UNITED STATES PATENT AND TRADEMARK OFFICE

APPLICATION NO.	FILING DATE	FIRST NAMED INVENTOR	ATTORNEY DOCKET NO.	CONFIRMATION NO.
10/673,643	09/30/2003	Victor T. Massey	081589-0306133	1141

Office Action Summary

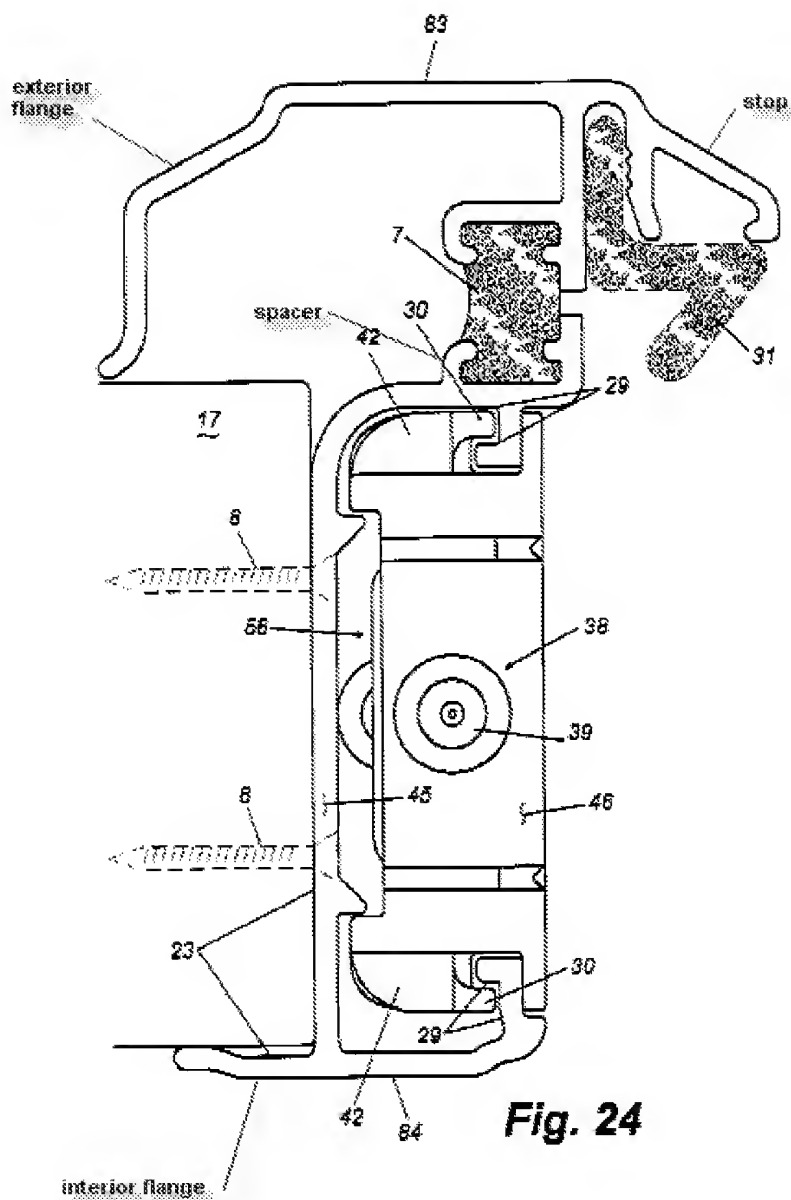
However, Selzer discloses an astragal 80 comprising a spacer 82 having a distal end (not numbered, but shown in figure 2) protruding outwardly from a major surface

(not numbered, but shown in figure 2) of a side portion in a direction that is substantially parallel to an interior flange 83 and substantially perpendicular to said major surface.

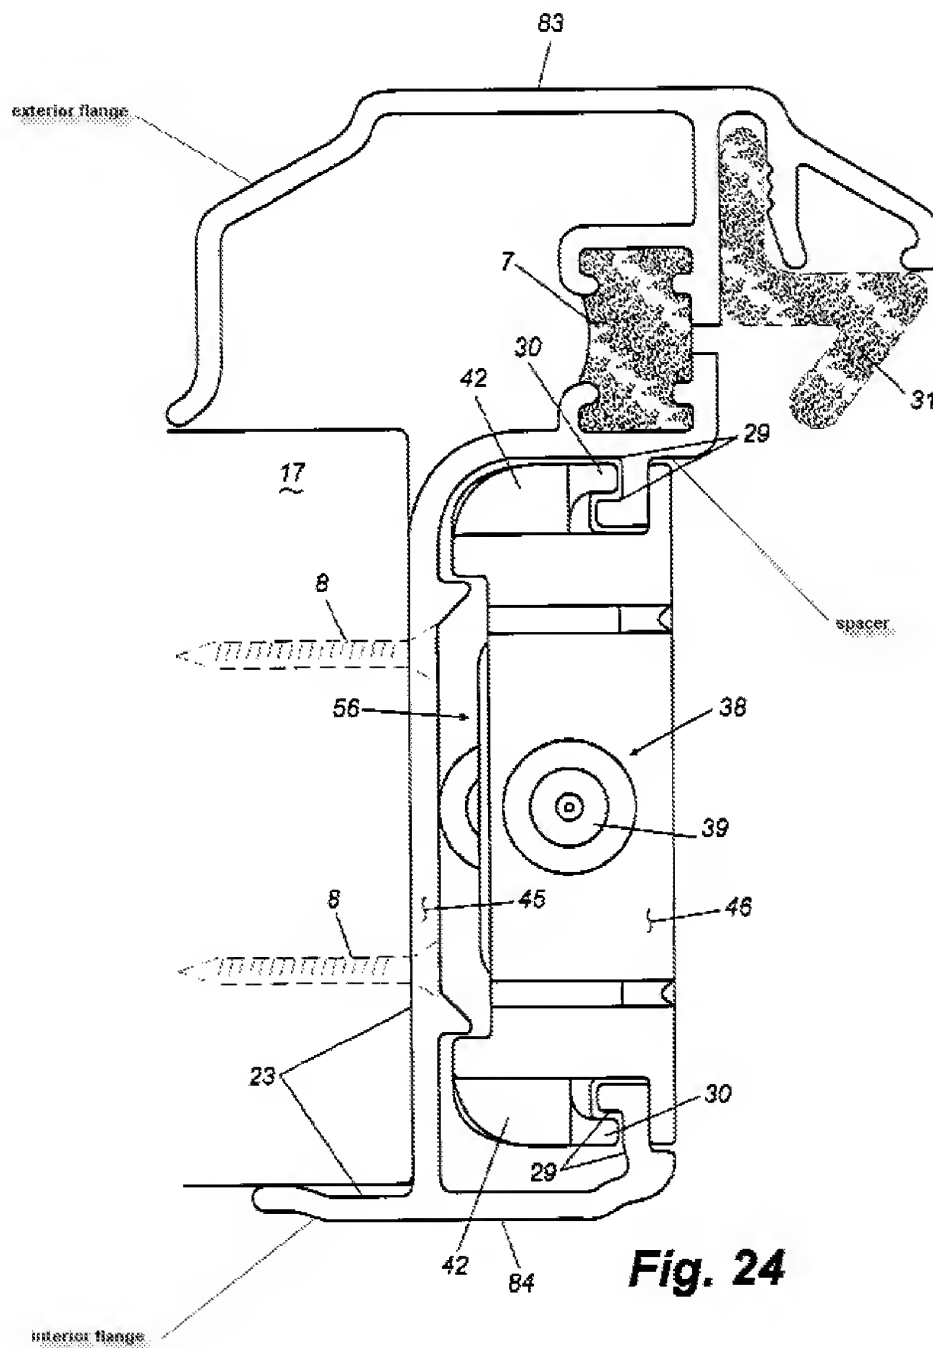
at least one elongated spacer (labeled below) extending directly from said side portion and having a distal end that engages said insert, said at least one spacer maintaining said wooden insert in position within said opening;

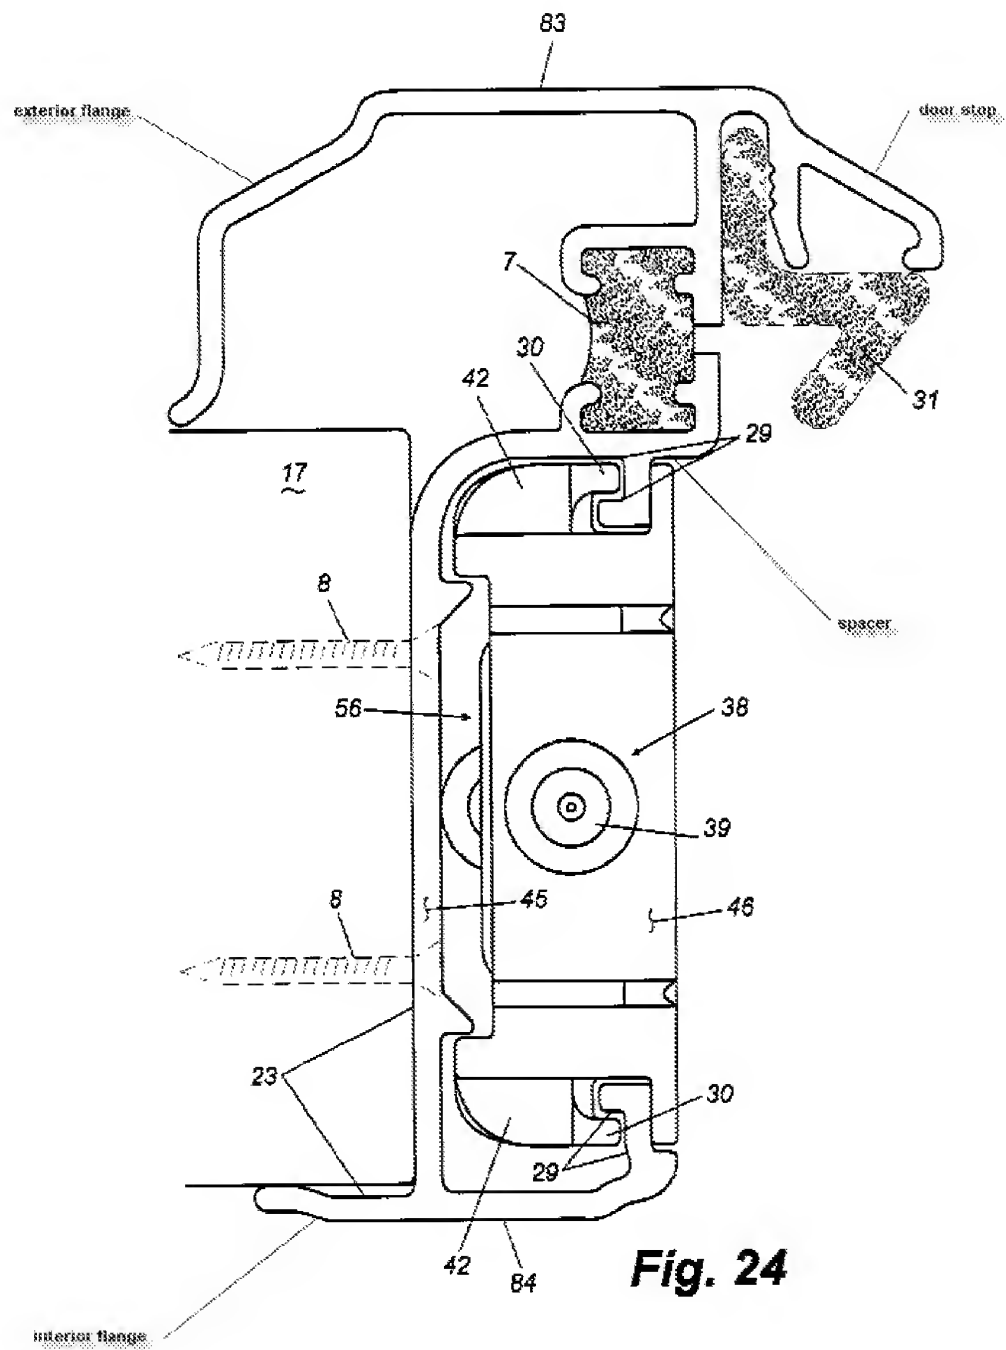
a frame 28 including an interior portion 84, an exterior portion 83 spaced apart from and opposed to the interior portion, a side portion 45 extending between the interior portion and the exterior portion opposite to the outer end of the passive door when the astragal assembly is attached thereto, a gasket 7 interconnected between the exterior portion and the side portion, an interior flange (labeled below) extending from

where the interior portion meets the side portion to engage the interior surface of the passive door when the astragal assembly is attached thereto, an exterior flange (labeled below) extending from where the exterior portion is connected to said gasket to engage the exterior surface of the passive door when the astragal assembly is attached thereto, a channel formed by the exterior portion, the interior portion, and the side portion of the frame, and a door stop (labeled below) extending from the exterior portion of the frame on the opposite side from where the exterior flange is located, said door stop for engaging the active door when the astragal assembly is attached to the passive door;
